Work Order ID 133150

Item Name: Basket Hoop

DESIGN	<i>[Signature]</i>	DRAWN BY	<i>[Signature]</i>	DART AEROSPACE LTD	REV. A
				HAWKESBURY, ONTARIO, CANADA	
CHECKED	<i>[Signature]</i>	APPROVED	<i>[Signature]</i>	DRAWING NO.	SHEET 1 OF 1
				D3166	
DATE	02.07.10	TITLE	BASKET HOOP	SCALE	NTS
A	02.07.10	NEW ISSUE			
A1	<i>[Signature]</i> 04.04.08	38+/- WAS 36.0

DRAWING NO. D3166	TITLE BASKET HOOP	REV.A1	DART AEROSPACE LTD ENGINEERING ORDER		D.E.O. NO. D3166-A-2	SHEET NO. 1 OF 1	SCALE NTS
DRAWN... AJS	CHECKED <i>[Signature]</i>	MFG. APPR. <i>[Signature]</i>	APPROVED <i>[Signature]</i>		DE APPR. <i>[Signature]</i>		
DATE 08.12.11	DATE 08.12.15	DATE 08/12/15	DATE 08/12/16		DATE 08.12.16

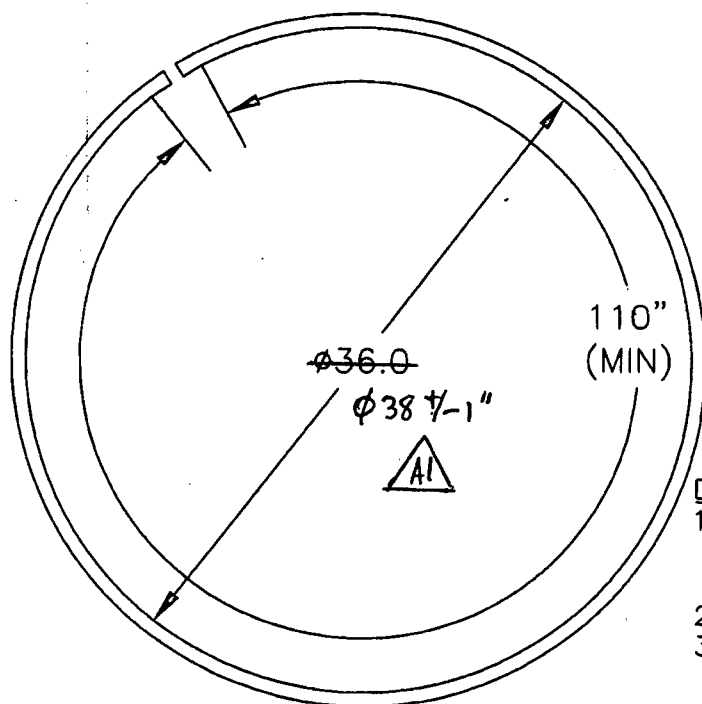
10.6 (REF, NEED 8.0 MIN)

1) MODIFY MATERIAL NOTE FOR D3166-1 AS SHOWN:

IS:

1) MATERIAL: AISI 304/316 SS, 3/4 X 3/4 X 0.065 WALL SQUARE TUBING,
60.00" LONG
REF. DART SPEC M304TS0.750W.065

WAS:

1) MATERIAL: AISI 304/316 SS SQUARE TUBING,
0.75" x 0.75" x 0.063 WALL, 60.00" LONG
(REF DART SPEC. M304TS0.750W.063)

2) MODIFY MATERIAL NOTE FOR D3166-3 AS SHOWN:

IS:

1) MATERIAL: AISI 304/316 SS, 3/4 X 3/4 X 0.065 WALL SQUARE TUBING,
120.00" LONG
REF. DART SPEC M304TS0.750W.065

WAS:

1) MATERIAL: AISI 304/316 SS SQUARE TUBING,
0.75" x 0.75" x 0.063 WALL, 120.00" LONG
(REF DART SPEC. M304TS0.750W.063)
